1.0 Introduction

This Response to Submissions (RTS) has been prepared by Ethos Urban on behalf of Lendlease Communities in respect of a Section 75W modification application (MOD 4) to the approved Calderwood Valley Concept Plan (MP09_0082). The modification seeks to allow for increased and more diverse housing supply at the Calderwood Urban Development Project (CUDP). Specifically, the modification application, as lodged sought to increase the number of principal dwellings permitted from approximately 4,800 principal dwellings to approximately 6,500 principal dwellings. The increase in housing supply is proposed to ensure that the existing area of urban zoned land in the CUDP is efficiently used for the continued supply of a range of housing types and lot sizes that both meet market demand and will assist in addressing housing affordability pressures in the Illawarra region.

2.1 Department of Planning, Industry and Environment

Figure 1 Areas satisfying locational criteria for additional density

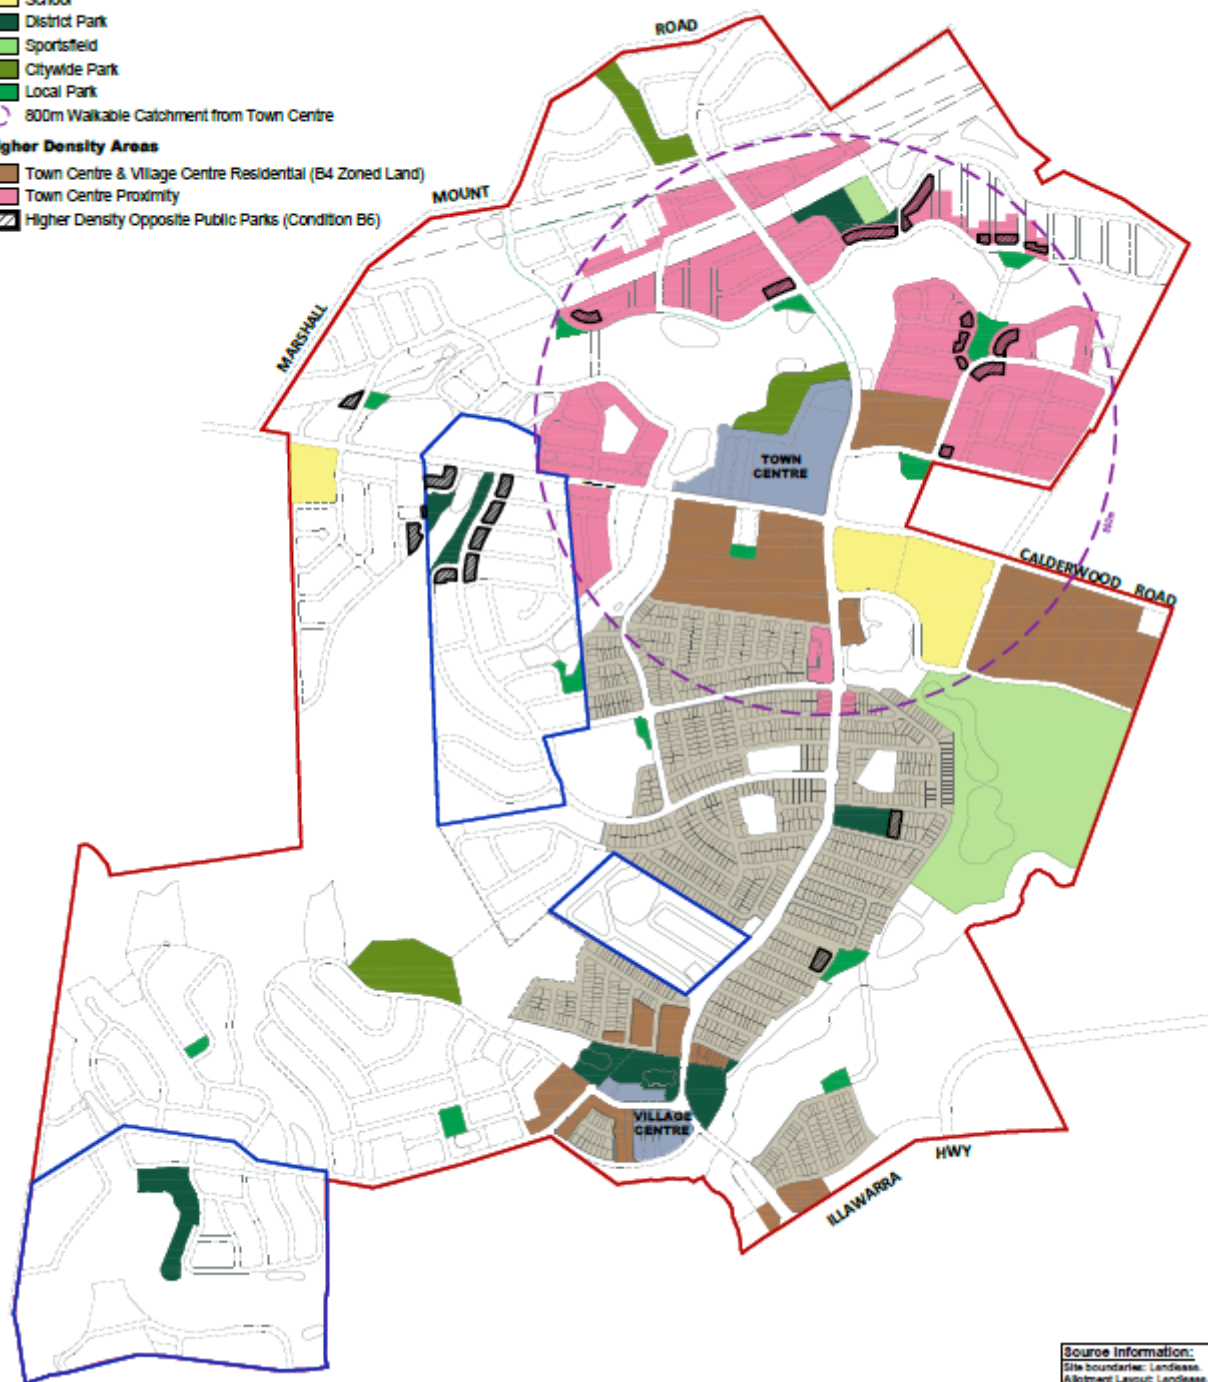
The DPIE requested additional information to understand the location of the additional density proposed as part of Modification 4 to the Concept Plan. The revised Urban Design Report prepared by RPS and submitted at **Appendix C** includes updated illustrative maps for information purposes. The additional density is only proposed in areas within 800m walking distance of the Town Centre and in areas opposite or adjacent to local parks with an area greater than 0.2ha (consistent with the Shellharbour VPA) and where the gradient is less than 1 in 10 as shown in pink and hatched black in **Figure 1**. Higher density was already permissible within the B4 Mixed Use Zones of the Town and Village Centres (coloured brown in **Figure 1**) and on land opposite or adjacent to local parks with a minimum area of 0.3ha or located directly opposite the town and village centres pursuant to Condition B6 of the Concept Plan. In response to issues raised in other submissions, the locational criteria for increased density on sites within 400m of the Village Centre has been removed from this application such that increased density is no longer proposed on land within 400m of the Village Centre, except as provided by Condition B6.

A radius of 800m is generally accepted as being within ten-minutes walking distance of the centre. RPS has undertaken a pedshed analysis which has demonstrated that the areas shaded pink at **Figure 1** are within ten minutes walking distance when walking along local roads and pedestrian paths.

It is noted that the location of the seniors dwellings is no longer identified on the indicative layout plan. This is to enable a more flexible approach such that they can be delivered within either the residential zone or within the Town or Village Centres. Lendlease is committed to delivering the 270 seniors dwellings and these have been accounted for in the total 6,000 principal dwellings, refer to Section 2.3. An aged care facility (up to 144 beds) will also likely be developed within the CUDP.

Figure 2 Flood levels in relation to Stage 1 Bridge

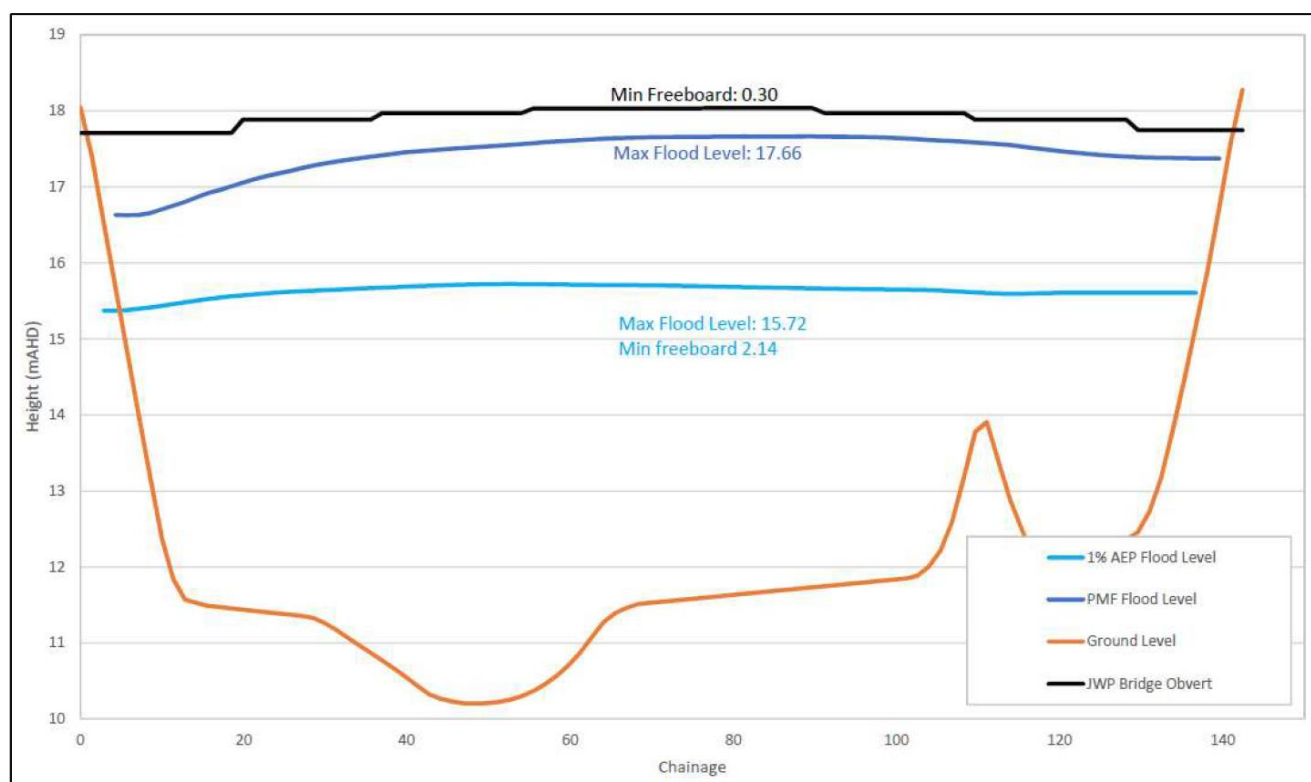
There were some specific concerns raised with the potential flood impacts surrounding Stage 1 of CUDP and the associated Stage 1 bridge across the Macquarie Rivulet. The Stage 1 bridge was granted a series of both development and construction approvals from various authorities before the construction of the bridge in 2016. The construction certificate approval was granted by SCC and the Subdivision certificate approval was also granted by SCC in 2016, demonstrating that at that time, SCC was of the view that the bridge was constructed at the levels with the approved documentation.

A detailed review of modelling parameters affecting the Stage 1 bridge has been undertaken and detailed at Section 9.1 of the WCFM Post Exhibition Report and further refinements including refining the modelling of the Stage 1 bridge based on Work As Executed information has been completed (demonstrated in **Figure 2** below). The flooding impact within Stage 1 area has been managed by the inclusion of a blade wall on the southern side of Escarpment Drive between the Stage 1 bridge and Brushgrove Circuit. The height of the wall varies across its length with a maximum height of 620 mm. This wall eliminates flooding within Stage 1 lots during the PMF event. This wall will form part of a future development application for SCC approval.

Figure 3 Completed sections of Escarpment Drive with shared path on eastern side only

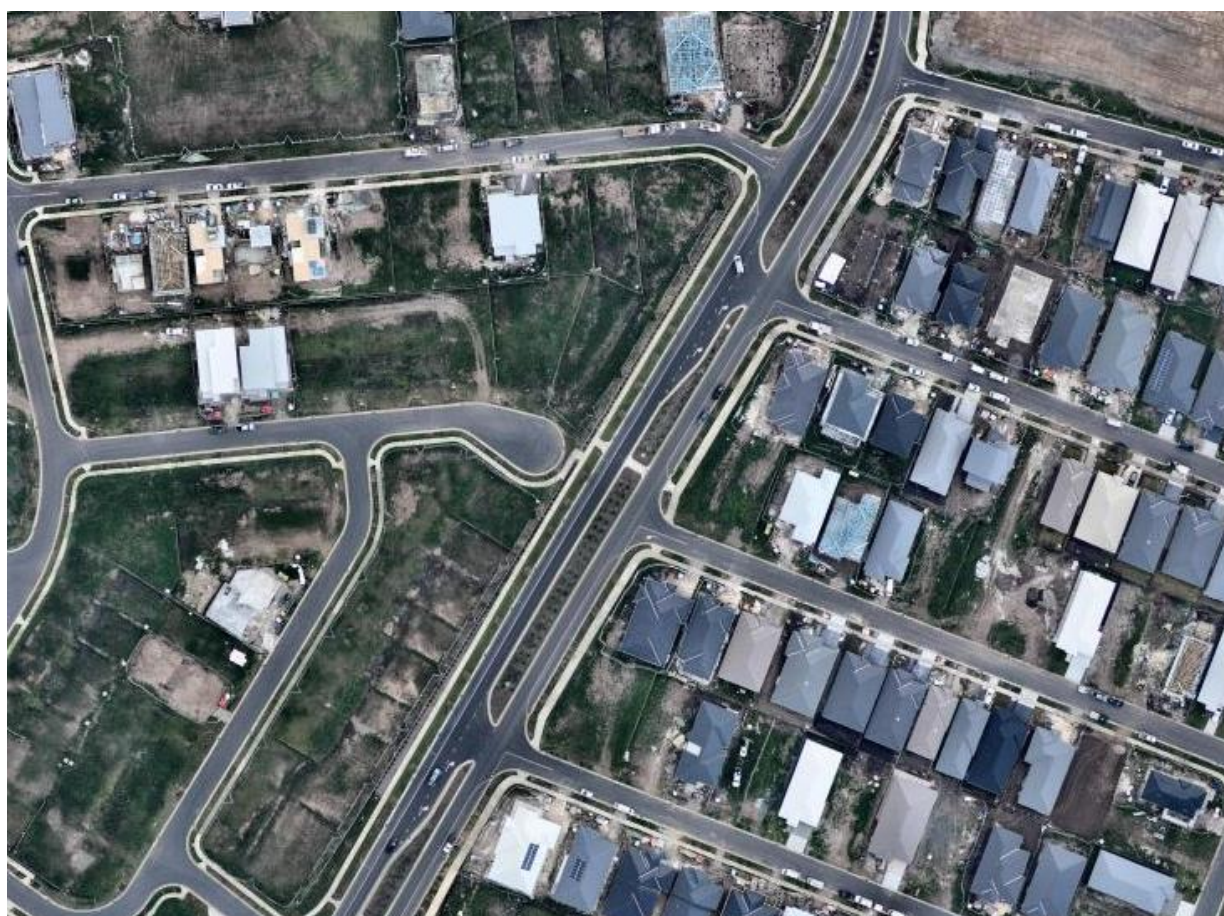
The Department requested additional information to address the transport and accessibility issues raised in the RMS, WCC and SCC submissions. Additional information has been prepared by Cardno, providing a detailed response to traffic and accessibility issues and submitted at **Appendix H**.

The shared path on the eastern side of Escarpment Drive is proposed for consistency with the current approved layout which is built and already in place, south of Calderwood Road (see **Figure 3**). Having a pedestrian footpath on one side and a shared path on the opposite side is considered appropriate and sufficient for this location. It provides pedestrians the choice to walk on one side of the road or the other and helps clearly direct cyclists to the designated shared path route and provides a safe pedestrian only route.

Having a shared path on the western side of the north-south sub-arterial (Escarpment Drive) would result in cyclists travelling south along this corridor having to cross the road at the intersection with Calderwood Road, given there is no shared path on the western side of the road past this point. Having shared paths that don't follow logical routes and force cyclists to do multiple crossings generates safety risks for all users, especially more vulnerable groups such as children riding to/from school.
